PRINGLE SUBDIVISION

APPLICATION NUMBER 14 DATE February 4, 2010

REQUEST Subdivision

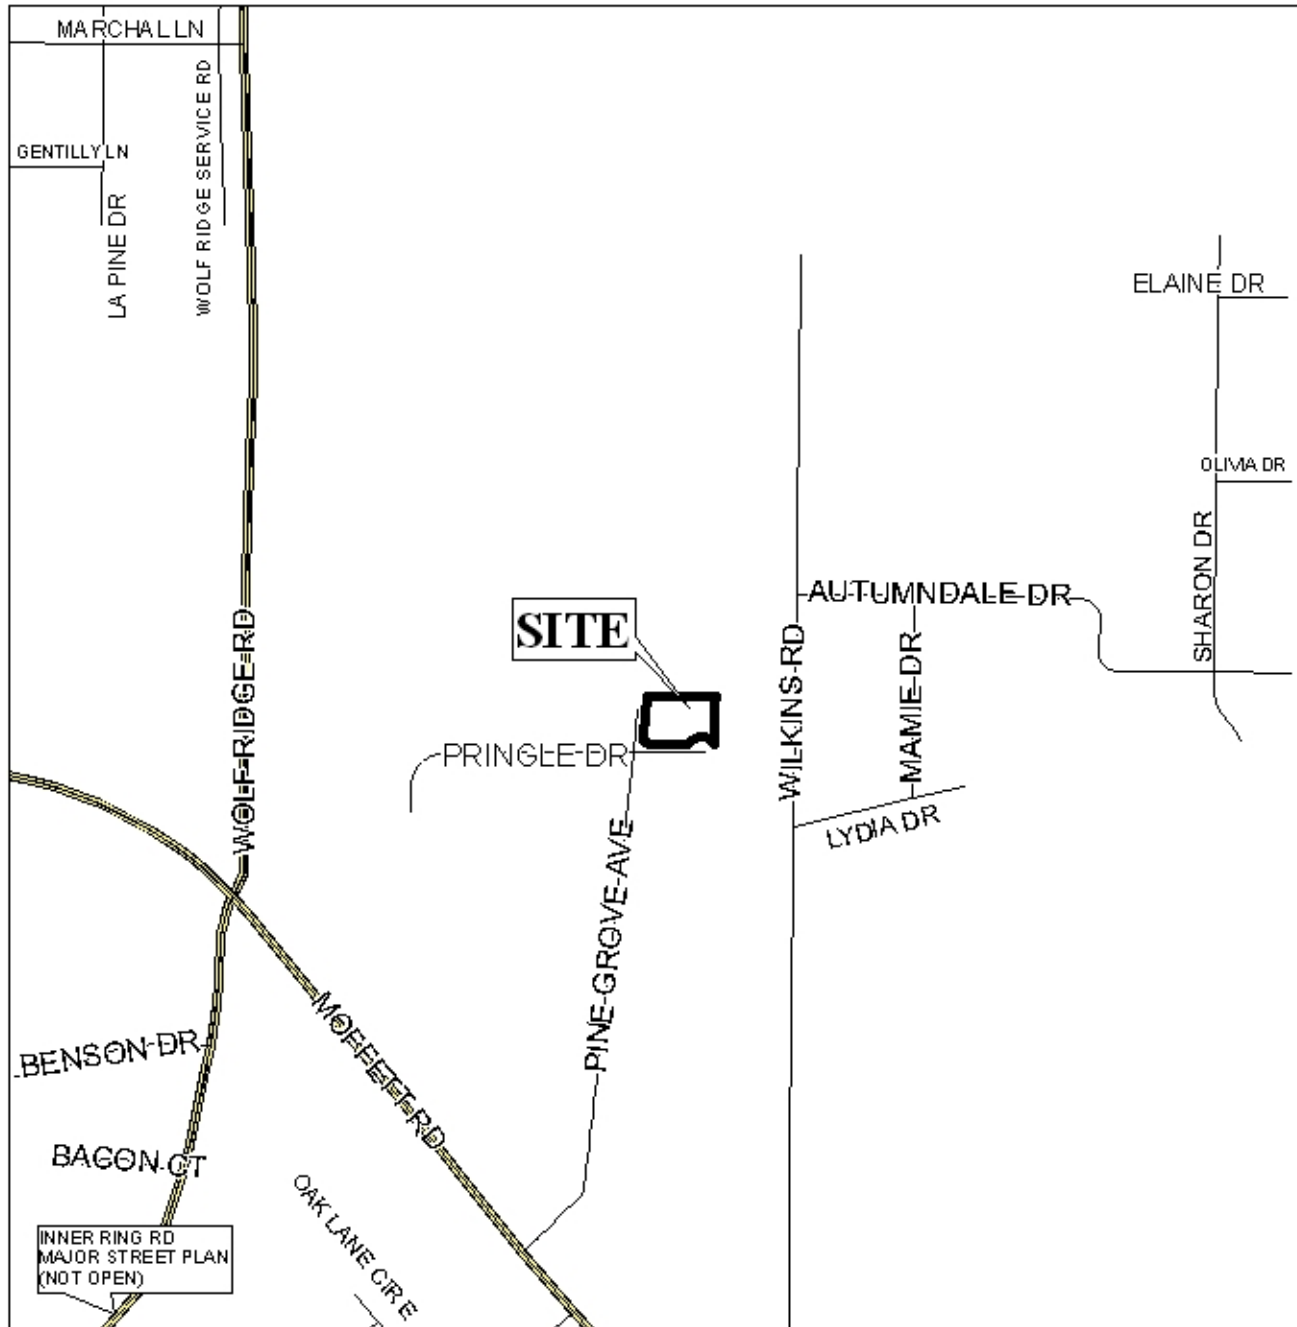
The plat illustrates an 18' curb radius at the intersection of Pringle Drive with Pine Grove Avenue, which does not comply with Section V.B.16 of the Subdivision Regulations. However, due to the site being part of an existing recorded subdivision, a waiver be appropriate.

The applicant should also revise the plat to depict a 25' minimum building setback line along both street frontages.

The site fronts a turn-around of a closed end street. It should be noted that the existing right-of-way of the turn-around is approximately 84' in diameter, which does not comply with the 2003 International Fire Code (120' required). However as already mentioned, the street is part of an established neighborhood; therefore, a waiver of this requirement can be justified.

It should also be noted that structures currently exist on Lots B and C; however, as noted the plat, they are to be demolished.

With a waiver of Section V.B.16 of the Subdivision Regulations, this application is recommended for Tentative Approval, subject to the following conditions:

- 1) placement of a note on the final plat stating that each lot (including the corner lot) is limited to one curb cut, with the size, location, and design to be approved by Traffic Engineering and in conformance with AASHTO standards;
- 2) the depiction on the final plat of the 25' minimum building setback line along both street frontages;
- 3) demolition of the existing structures on Lots B and C prior to signing the final plat; and
- 4) placement of a note on the plat stating that approval of all applicable Federal, state and local agencies is required for endangered, threatened or otherwise protected species, if any, prior to the issuance of any permits or land disturbance activities.
